ATTACHMENT 1 DEVELOPMENT SERVICES

DETAILED ASSESSMENT REPORT

SUMMARY SHEET	
APPLICATION DETAILS	
Applicant:	Parmac Property Group
Proposal	<ul style="list-style-type: none"> • Development Permit for Material Change of Use (Service Station) • Development Permit to Reconfigure a Lot (2 Lots into 2 Lots)
Properly Made Date:	05/10/2017
Information Request Date:	24/10/2017 – Information Request sent 8/03/2018 – Further Advice Letter sent
Information Response Received Date:	7/02/2018 – Information Response received 28/03/2018 – Further Advice Response received
Decision Due Date:	1/06/2018
Number of Submissions:	330 properly made + 92 not properly made 3 petitions (268 signatures total)
PROPERTY DETAILS	
Division:	9
Property Address:	227 & 229 Nambour Connection Rd WOOMBYE
RP Description:	Lot 1 & 2 SP 119132
Land Area:	13,148m ²
Existing Use of Land:	Various uses including landscape supply yard, storage/hire yard, motor vehicle workshop
STATUTORY DETAILS	
Planning Scheme:	Sunshine Coast Planning Scheme (31 July 2017)

Figure 3: Proposed Service Station Site Plan (and access easement over proposed Lot 2)

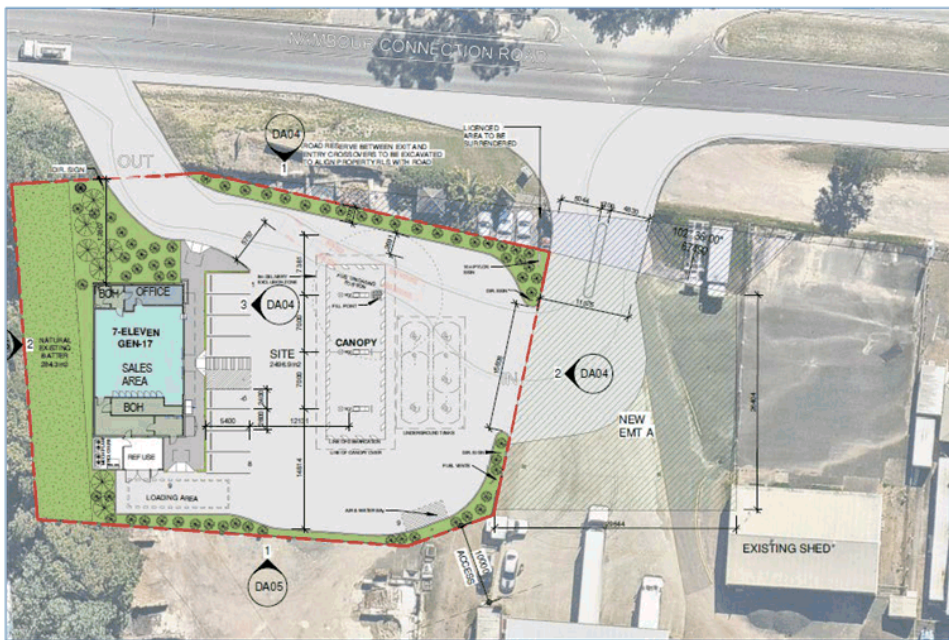
The proposed fuel canopy has a setback of 7.5m from the existing State-controlled road licence area boundary. However, this licence area is to be surrendered to facilitate the new driveway access and, as a result, the front boundary setback of the proposed fuel canopy will be 4.7m to the property boundary.

The existing verge on Nambour Connection Road is sufficiently wide in this location so as to provide a setback of the fuel canopy to the road pavement of 16 metres. This setback, coupled with the requirement for a 2.0m wide landscape strip along the site frontage and additional planting within the site, would complement the rural setting of the site.

It is considered the proposal meets the performance outcome in this instance as the reduced fuel canopy setback:

- would not impact on the safe and efficient use of the site
- would not create any adverse visibility or traffic safety issues for vehicles travelling on Nambour Connection Road

- would improve the existing streetscape character with additional landscaping along the road frontage
- provides more than adequate separation to adjoining uses.
